POCONO TOWNSHIP PLANNING COMMISSION

AGENDA

December 9, 2024 6:00 p.m.

**SUBJECT: 437-439 SCOTRUN AVENUE
SKETCH PLAN REVIEW
POCONO TOWNSHIP, MONROE COUNTY, PENNSYLVANIA
POCONO TOWNSHIP LDP NO. 1436, T&M PROJECT NO. POCO-R1010**

DESCRIPTION:
SITE PLAN

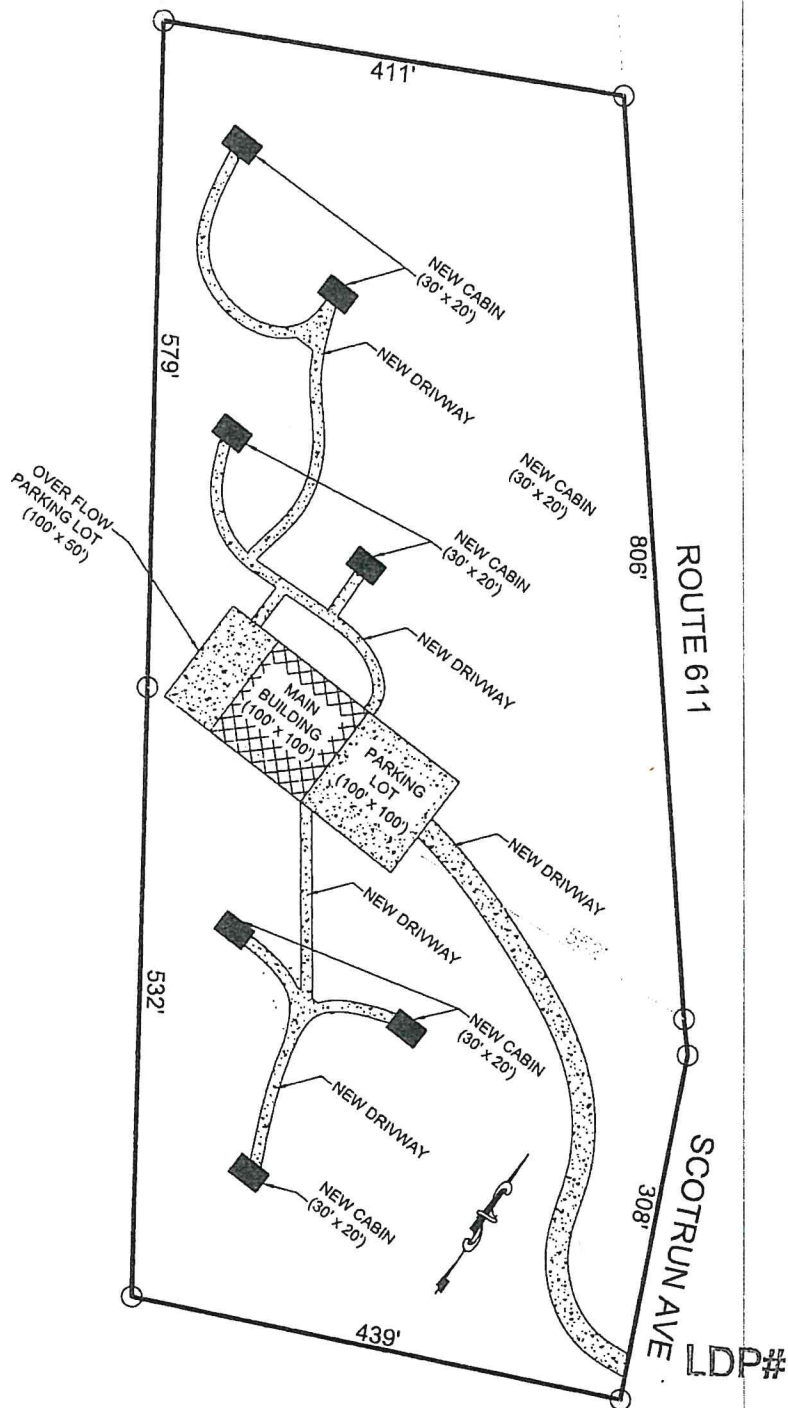
26. It is noted that the Site Plan boundary lengths are different than those shown on the Survey Plan. The Applicant must confirm the boundary prior to preparation of any Land Development Plans.

27. The two (2) properties must be consolidated as part of any Land Development application.
28. The driveways to the cabins, as depicted on the Site Plan, do not provide adequate radii to permit vehicular turning movements. This must be considered during site design.

29. The Site Plan depicts new driveways immediately adjacent to the "main building". These driveways must be moved away from the building from a practical and safety perspective.

30. Parking and turnaround areas must be provided at each cabin.
31. Pedestrian access throughout the site shall be addressed on any future Land Development Plans. Walking trails would be an appropriate amenity to offer guests.

32. The location of trash dumpsters or other trash collection area(s) need to be shown. Future Land Development Plans will also need to demonstrate accessibility of the dumpsters by the trash trucks.
